HISTORIC AND DESIGN REVIEW COMMISSION

HDRC CASE NO: 2015-438

ADDRESS: 1123 BURNET ST

TYPE OF WORK: Door replacement and exterior modifications

Backdoor

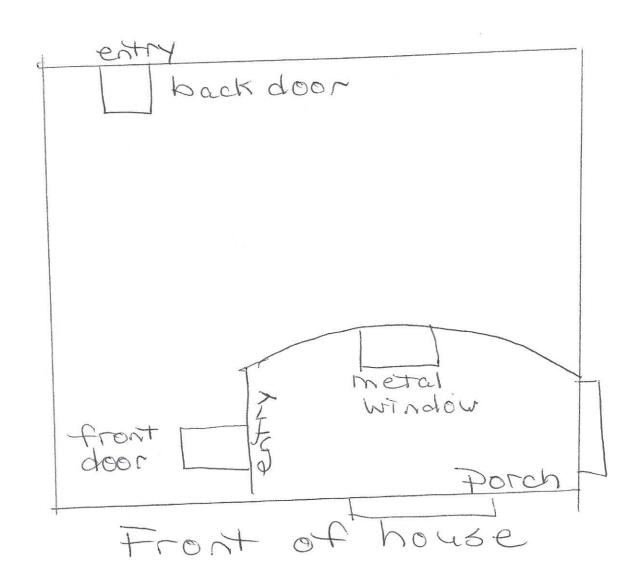
- a. The applicant has proposed to remove the two, existing metal doors and install a wood door at the front entrance and another steel door at the rear entrance. The applicant's proposed front door replacement is appropriate and consistent with the Guidelines. Given that the current rear door is a metal door, the applicant's proposal to replace it with a new metal door is appropriate.

Staff recommends approval of the installation of both the front wood door and the rear metal door.
